INDESIT company

Model type:
AML125EX

Commercial code:
F030590

n1040325: New shock absorber fixing system with pin

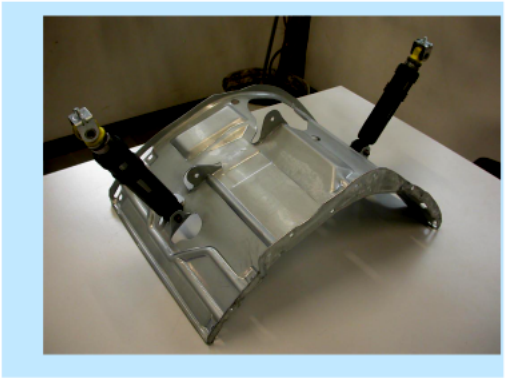
From serial no. 40427.0001, shock absorbers have been fixed to the tank unit cradle with two 11 mm pins code C00110163 (see fig. 01 and 02 enclosed) in place of the 8 mm screws code 093750 and relevant locking nuts code 030443, on all washing

machines and dryers produced in the Comunanza factory.
The items affected by this modification are:
1) The cradles have the same Service code, as they can be used in place of the new ones after widening the shock absorber fixing holes to a diameter of 10 mm.
Code 093848 - Tank unit cradle 46 lt
Code 093878 - Tank unit cradle 40 lt.
2) The new shock absorbers, with fixing bushing having no s/steel spacer, are not managed as they are interchangeable with the premodified items (make sure they are CIMA type, as the managed items), fixed with M8 screws code 093750 and related locking nut code 030443 (see figs. 05 and 06).
Code 093884 - Shock absorber 80 N
Code 093885 - Shock absorber 100 N

To remove the shock absorber from the tank, first extract the pin with a few hammer taps (see fig.03) until it is aligned with the tank bracket and then pull it out with a pair of pliers (see fig. 04).
(To refit the shock absorber use a new pin. Insert the pin until the toroidal edge is aligned with the bracket.)

Fig. n10402231

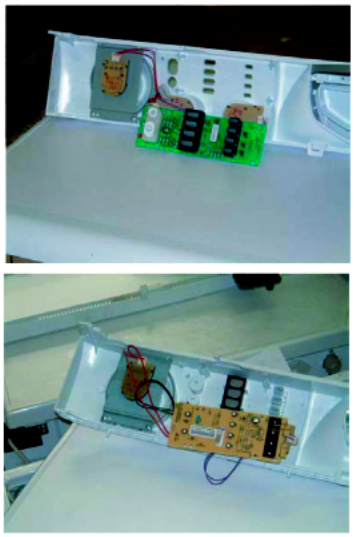
From serial no. 40429.0001, models AVL, AVXL, AVSL, AML have been equipped with a new panel with well holes for the ON/OFF and RESET buttons and flush plastic light diffusers in place of the projecting siliconed ones (see picture n10402231

Fig.02). These features determine whether an appliance is modified or premodification.
The modification has also involved the electronic card whose panel and display communication connectors are on the left and not at the back (see picture n10402232 Fig.2).

n1040342: New balancing system for washer-dryer models with spin cycle up to 1200 rpm.

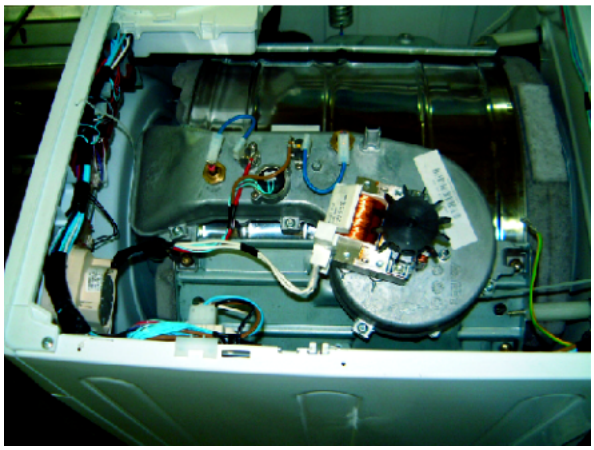
From serial number 41026.0001, all WIDL, AML, AMD washer-dryer models up to 1200 rpm produced in the Comunanza plant are equipped with a new balancing system for the mobile assembly (see fig.001).
The modification involves the following parts, which are not interchangeable with their premodification equivalents:

C00114386 - REAR COUNTERWEIGHT WD 6 kg;
C00114388 - DRYER KIT BLOWER BODY S/N 41026.0001;
C00114390 - BLOWER BODY FIXING SCREW SN 41026 M8X25S.P.P.
C00114487 - REAR COUNTER-WEIGHT FIXING SCREW M8X32TE.
In preparation for this modification, drum spiders already prearranged with fixing holes for the rear counter-weight (see attached image) have been installed on production appliances and included in the spare parts programme.

Fig . 001

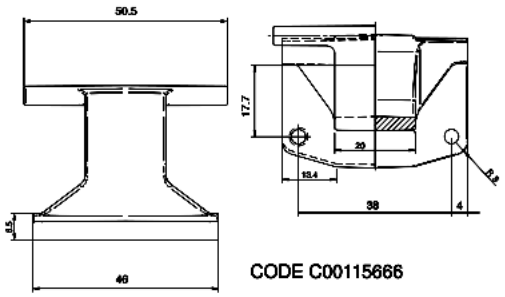
From serial no. 50207.0001, all Ariston models produced in the Teverola factory (see table 001 attached) with industrial code (given on the rating plate) starting with 46, have been equipped with a Zamac hinge with 150° opening angle, code C00115666 (see Fig.001).
This modification has involved the introduction of the following items:

Code C00115670 - Complete door EVOII 150° white 27 with standard glass;
Code C00115674 - Complete door EVOII 150° white 27 with long glass;
Code C00115667 - EVOII body for 150° hinge white 27;

Fig . 001

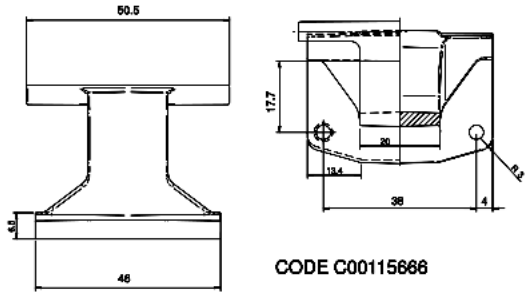
From serial no. 50207.0001, all Ariston models produced in the Comunanza factory (see table 001 attached) with industrial code (given on the rating plate) starting with 80, have been equipped with a Zamac hinge with 150° opening angle, code C00115666

(see Fig.001).
This modification has involved the introduction of the following items:

Code C00115670 - Complete door EVOII 150° white 27 with standard glass;
Code C00115674 - Complete door EVOII 150° white 27 with long glass;
Code C00115668 - Complete door EVOII 150° silver with standard glass;
Code C00115673 - Complete door EVOII 150° silver snella standard glass;
Code C00115662 - EVOII body for 150° hinge white 27
Code C00115663 - EVOII body for 150° hinge silver 27
Code C00115664 - Snella EVOII body for 150° hinge white 27
Code C00115665 - Snella EVOII body for 150° hinge silver
